L-0700-019
January 9, 2020

**Re: Lonza Biologics G2E– Proposed Parking Expansion
Site Plan Review Application**

PROPOSED PARKING EXPANSION

LONZA BIOLOGICS

SITE PLAN

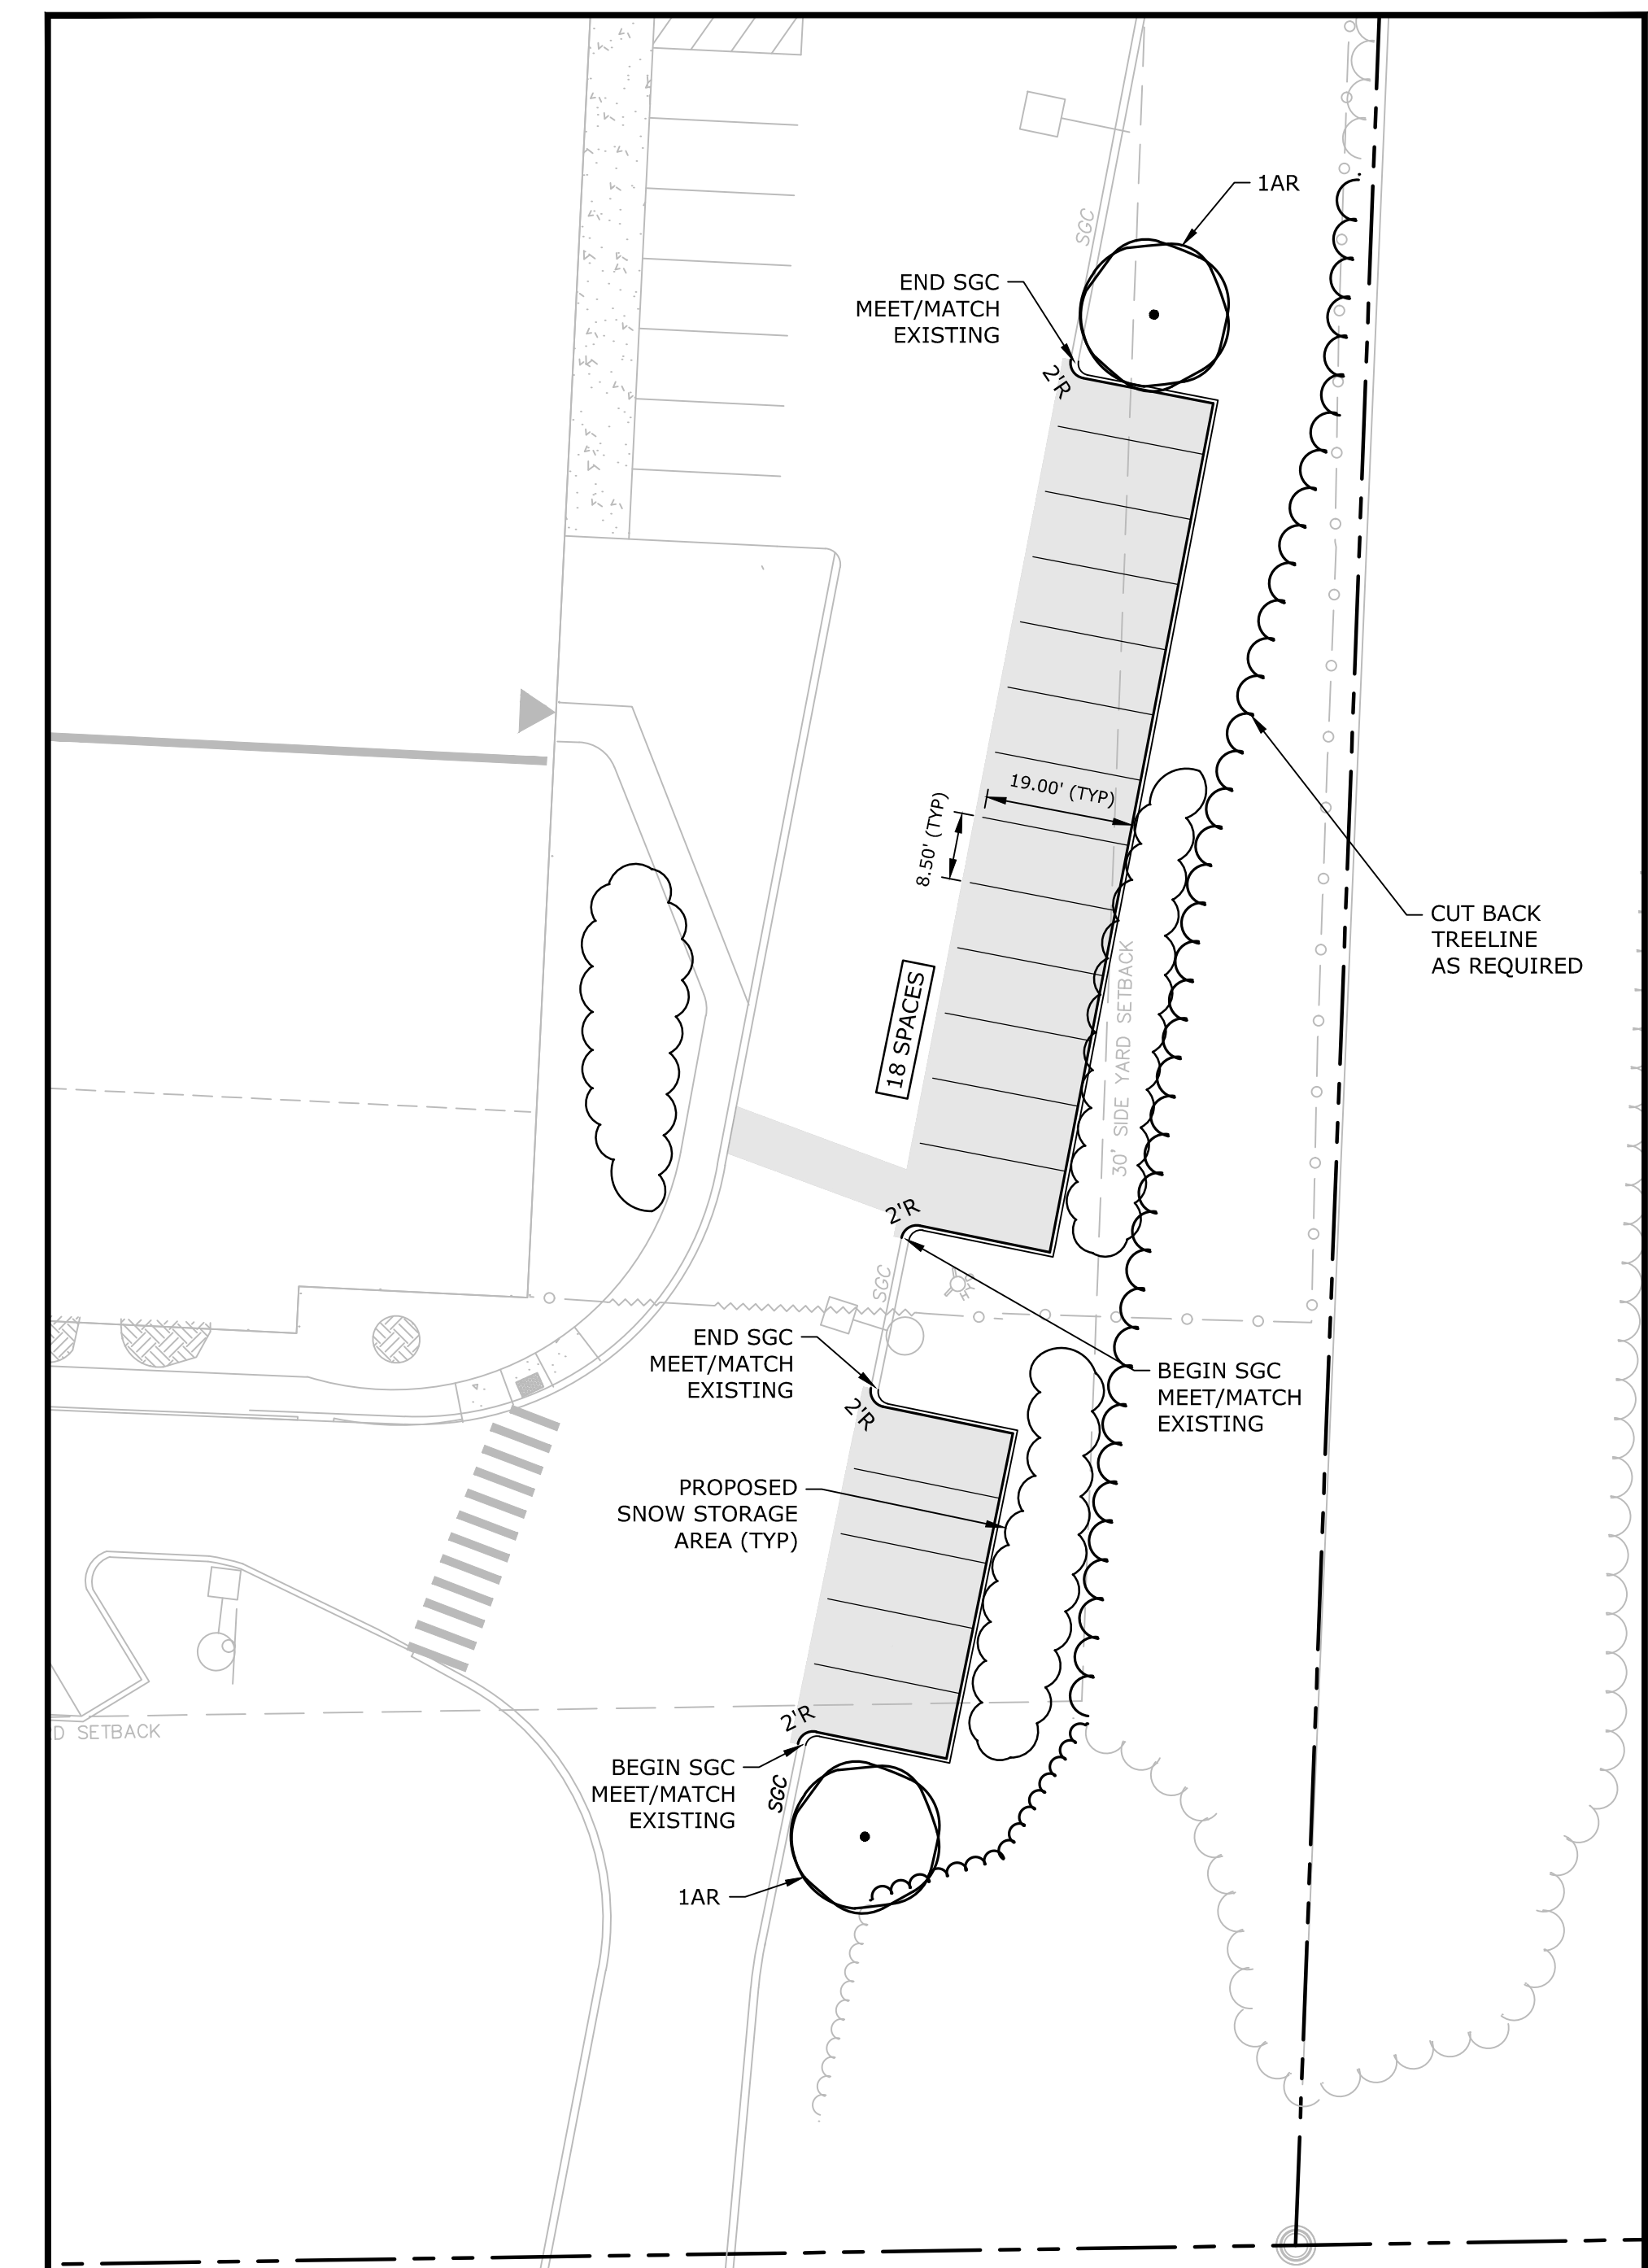
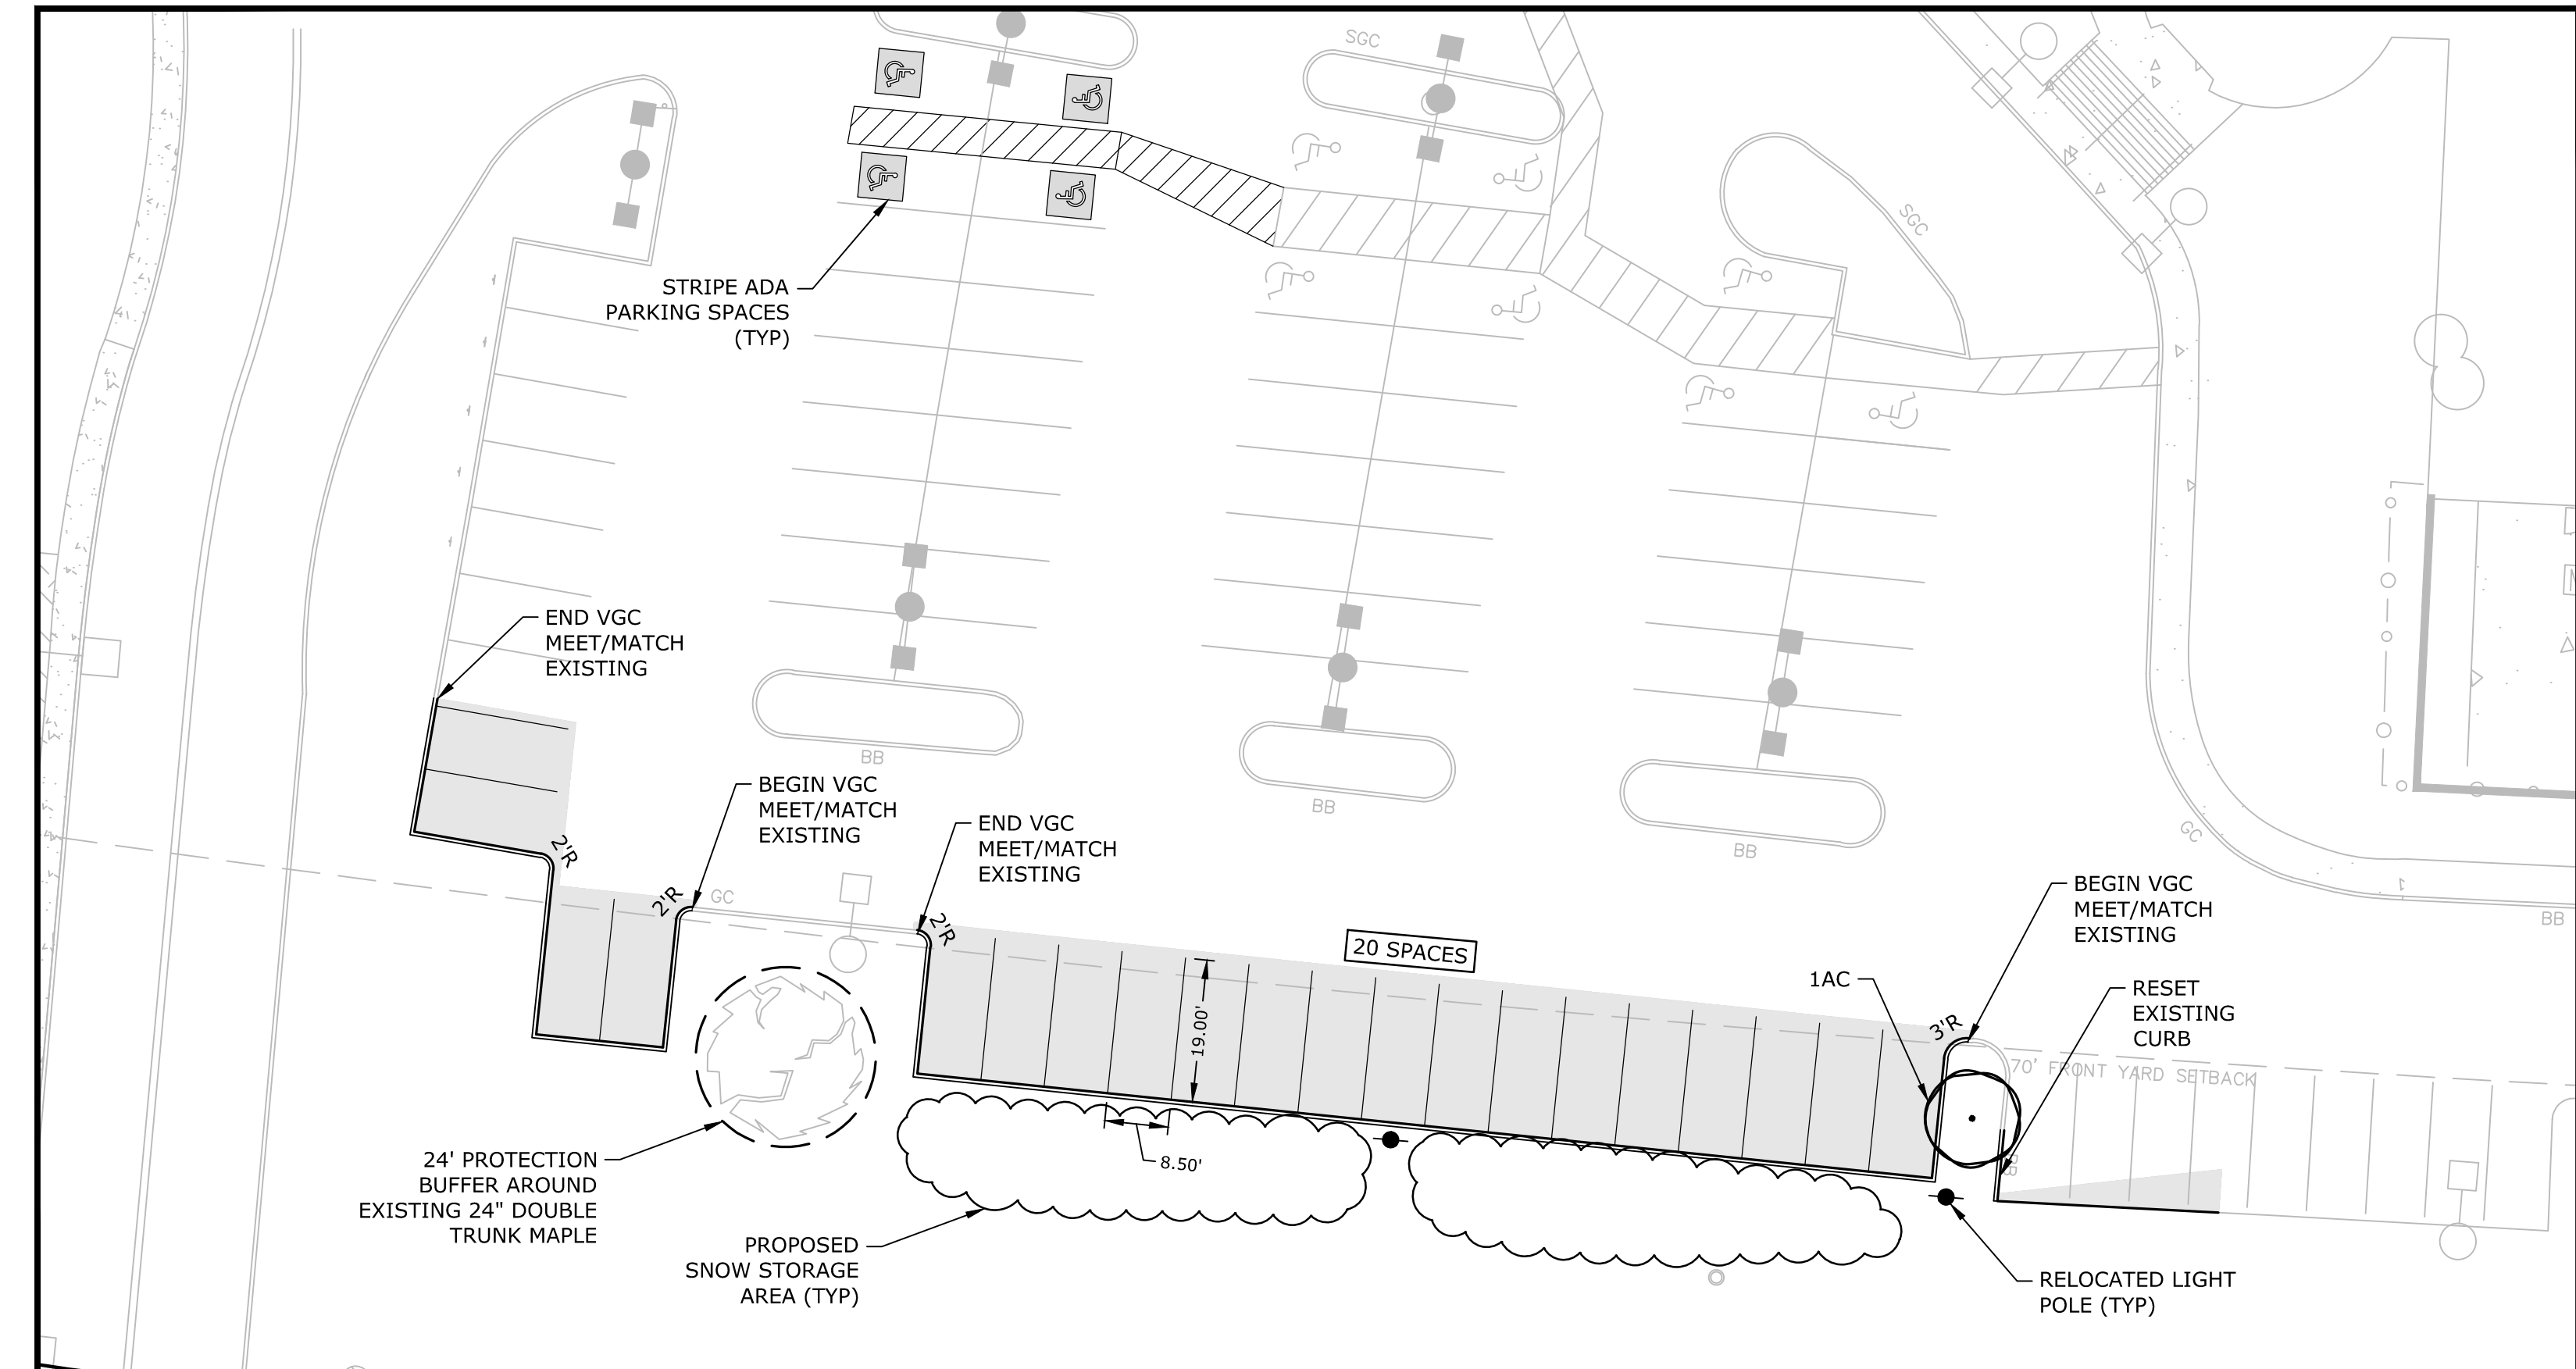
1. Plans shall be updated to include two more additional ADA spaces, closest to the building entrance, as required by standards.

2. Plans shall be updated to show replacement trees along the road where new parking is proposed, consistent with those that are planned for the opposite side of the road.

The number of required ADA parking spaces have been calculated by considering the garage and surface parking lots as two separate parking facilities. This makes the total required number of ADA spaces 15. There are 11 existing ADA spaces on site and an additional 4 ADA spaces have been added to the plans.

Trees have been added to the plans along Goose Bay Drive to replace the trees being removed as part of this project. Tree species have been chosen to match the trees planned for the opposite side of the road.
